Preliminary Urban Design Assessment

Council Ref. N/A
GMU Ref. 12032

Proposed Mixed Use Development at
27-31 Belmore Street, Burwood

September 2012

Visual privacy issues and insufficient western boundary setback for the southern tower. This condition is typical for levels 6-8.
(Adapted from Drawing DA2106 by AJ+C Architects)

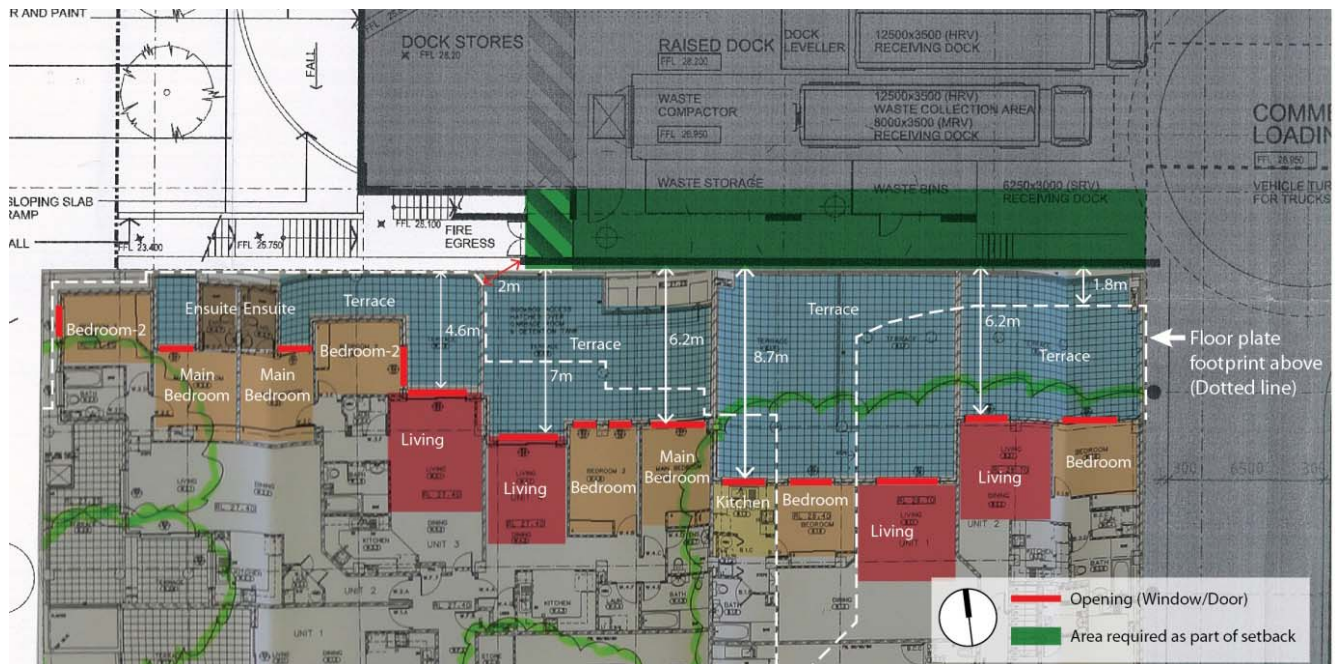
A similar extent of encroachment into the setback zone occurs on levels 4 to 17 to the western boundary against 33-35 Belmore Street. Although the southern tower's north-western units have bedrooms oriented with outlooks in the north-south direction, the setback of approx. 1.3m to the western common boundary is insufficient. The windows along the western facade of the southern tower are setback approx. 2.2m to the common boundary. Given that these windows are screened, the RFDC's building separation distances required are 9m (for levels 4-7/ up to 25m) and 12m (for levels 8-17/ over 25m) between non-habitable rooms. The tower encroaches into the minimum setback required to achieve equal sharing of separation distances. Furthermore, the lack of setbacks at higher levels results in excessive bulk and scale issues. The western apertures within the blade walls of the northern and southern balconies look into existing blank walls which is an undesirable outlook and it limits the redevelopment potential of 33-35 Belmore Street.

According to the RFDC's building separation distances, the minimum separation distances required between balconies/habitable rooms is 24m for levels 8-17/ over 25m. For levels 10 to 15, the balconies of units 1002, 1102, 1202, 1302, 1402 and 1502 have zero setback to the western boundary. This fails to provide any setback and therefore, it does not comply with the building separation distances. This is unacceptable as the proposal relies on borrowed amenity and hinders the opportunity of 33-35 Belmore Street to redevelop up to its 60m allowable LEP height.

Interface between level 1 of the proposal and ground level of the existing development at 33-35 Belmore Street
(Plan of the proposal adapted from AJ+C Architects; Plan of 33-35 Belmore Street adapted from Kimi Associates)

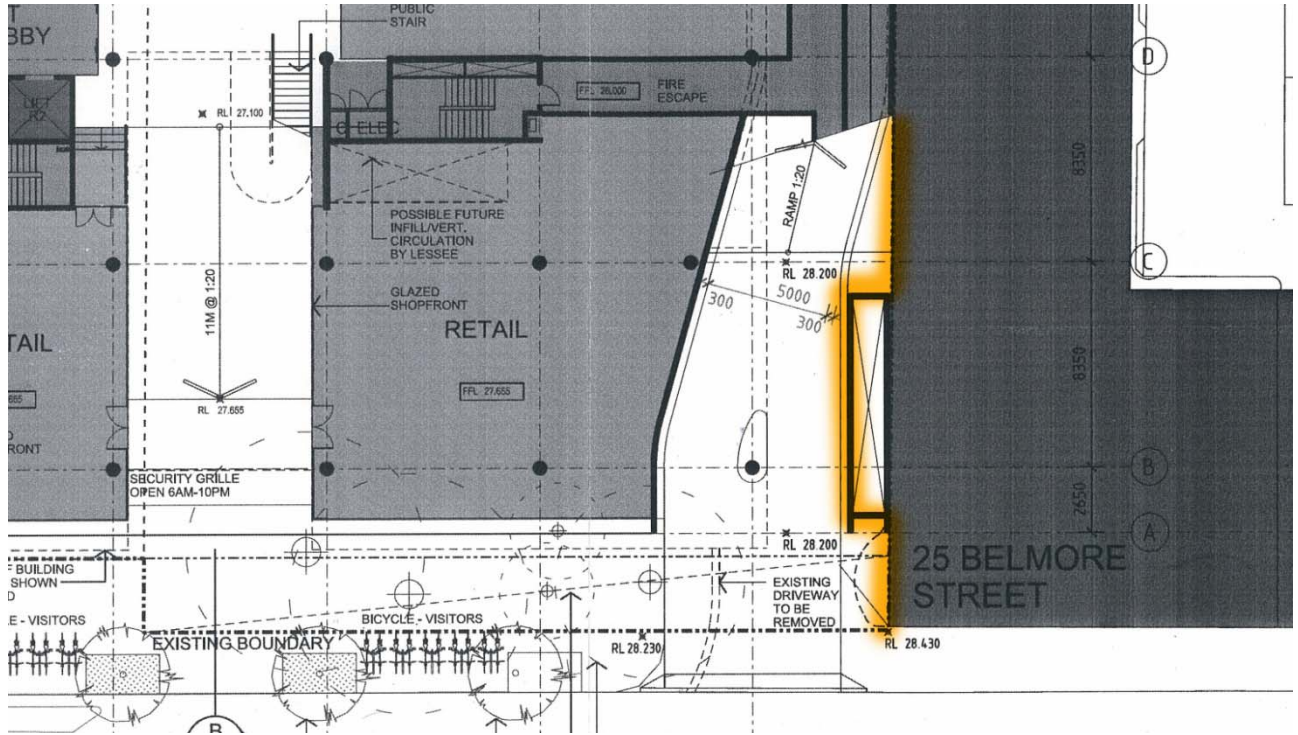
To the southern boundary of the subject site adjacent to 33-35 Belmore Street, the proposal's podium has zero setback on level 1 and 10.8m setback to the boundary for levels 2 and 3. The north facade of the existing 7-storey mixed use development at 33-35 Belmore Street is setback approx. 1.5m to the common boundary. Level 1's zero setback to the common boundary results in no separation distance to the northern units' living areas and private open spaces on the ground level of 33-35 Belmore Street, causing serious amenity impacts. For a discussion on the overshadowing concerns, please refer to Section 2.1.6 Overshadowing of this report.

According to architectural drawings by Kimi Associates (dated 9 May 2000), there are 5 units on the ground level of 33-35 Belmore Street which will be affected by the proposal's interface design, in particular units no.1, 2 and 4.

Although a roof garden is proposed on level 2 of the proposal's podium to the north of 33-35 Belmore Street, the blank wall on level 3 facing the existing northern residential units on levels 3-5 of 33-35 Belmore Street is considered to be unacceptable. The roof garden is not visible particularly when viewed from the living areas of those existing residential units. The proximity of the proposed podium results in the lost of outlook for the existing residential units on levels 2-5 of 33-35 Belmore Street. Visual and acoustic privacy as well as daylight access and outlook have been compromised for those existing residential units.

This report acknowledges that 33-35 Belmore Street fails to provide 50% of the required separation distance as this development pre-dates the RFDC. However, the proposal is expected to provide a reasonable interface between its loading area and the private open space of the affected residential units. The proposal should provide its 50% of the required RFDC separation distance at this level or at least step back for the zone marked in the above diagram.

Blank wall of 25 Belmore Street exposed to the public domain (Highlighted in orange).
(Adapted from Drawing DA2101 by AJ+C Architects)

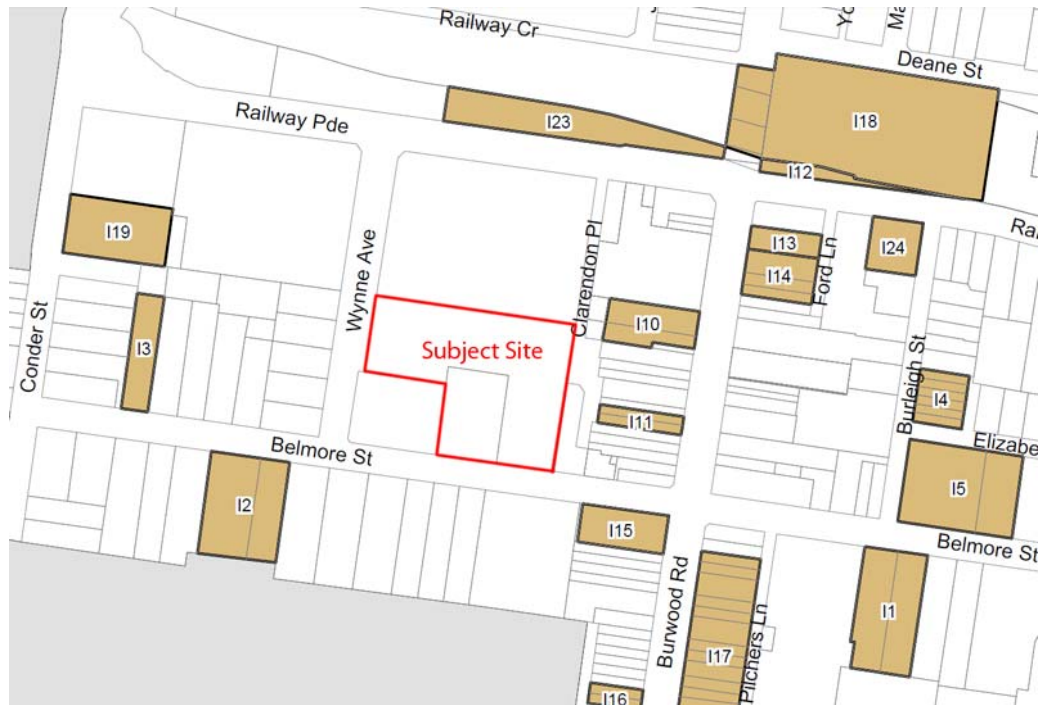
To the south fronting Belmore Street, the proposal observes the 3m setback requirement at ground level which aligns the street edge with the building line of the existing elevation at 33-35 Belmore Street. However, the 3m setback occurs to the eastern half of the frontage and, results in the western half of the frontage being set back approx. 1.5m. Furthermore, the western half of the frontage presents an awning that encroaches over the lot boundary into the public domain. This fails to comply with the DCP Clause 2.2.1.2 Provision P2 where setback areas must be free of any projections or encroachments. The proposal has achieved a distinct separation between the entrance to the retail and residential uses, which is a positive outcome. As no. 25 Belmore Street has zero street front setback, the Burwood Plaza vehicular exit along the existing access easement can potentially result in a perceivable blank wall along the 2-storey commercial building at 25 Belmore Street. Articulation or material treatment is required in order to ensure that no visual impacts will derive from the exposure of blank wall conditions.
